ADDENDUM NO. 1  
TO THE CONTRACT DOCUMENTS  
for the construction of

Date: 6/1/18  
Project No.: 691778

**SHAMROCK, BLALOCK & HOOPER RESERVOIRS – WATER QUALITY IMPROVEMENTS**

CLAYTON COUNTY WATER AUTHORITY  
CLAYTON COUNTY, GEORGIA

TANK NAME:	FERRIC CHLORIDE DAY TANK		
TAG NUMBER(S):	155T		
QUANTITY:	1		
SERVICE:	FERRIC CHLORIDE (40%)	SPECIFIC GRAVITY:	1.42
pH RANGE:	< 2	TEMP. RANGE (°F):	AMBIENT
DIAMETER:	3 FEET - 10 INCHES	STRAIGHT SHELL HEIGHT:	4 FEET - 5 INCHES
CAPACITY:	295 GALLONS

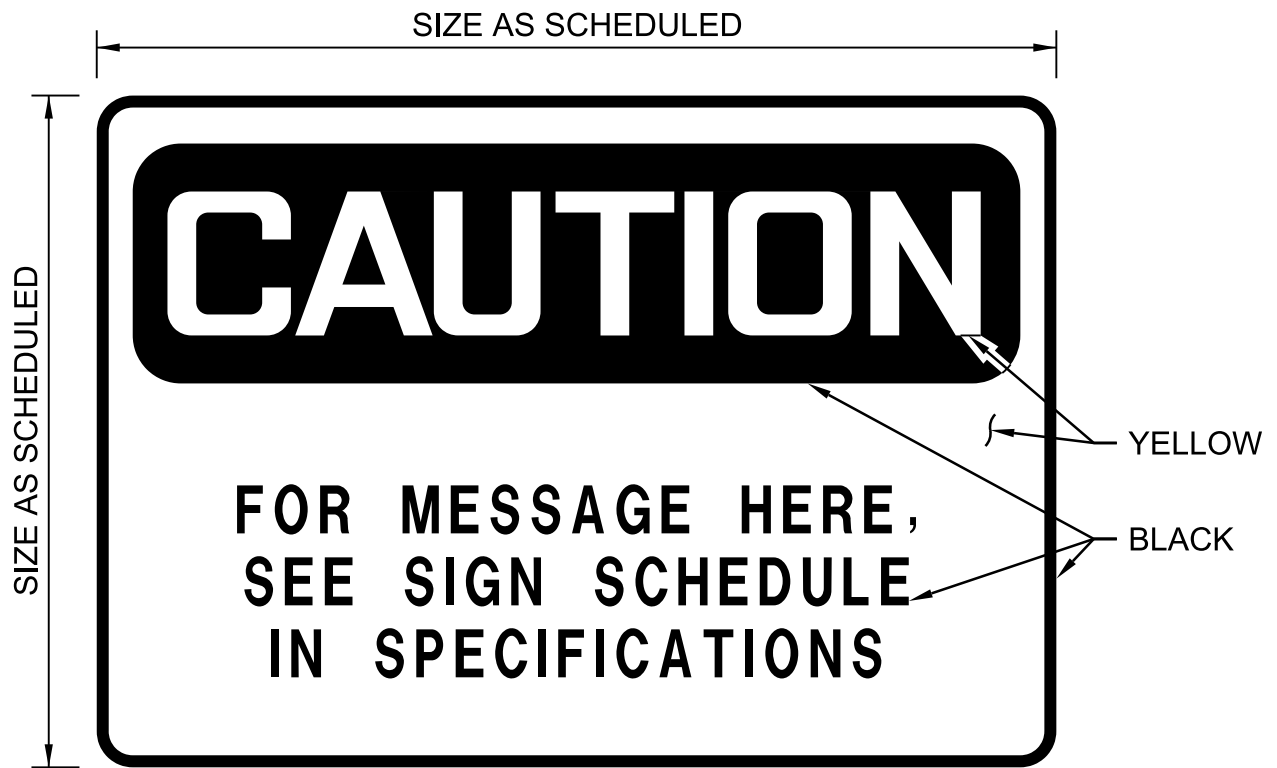
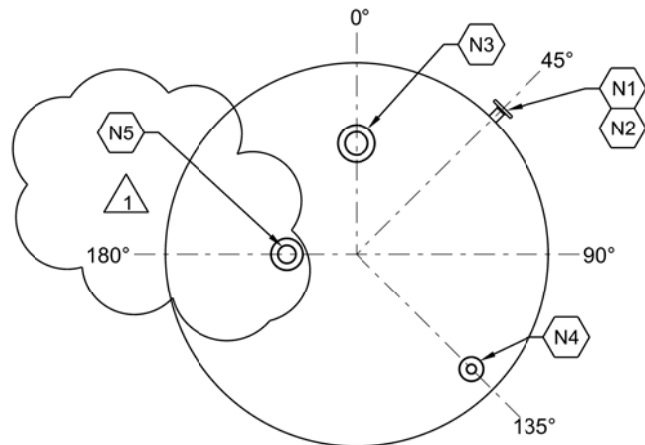
Supplement 1, 155T Ferric Chloride Day Tank Data Sheet DELETE and REPLACE with the attached.
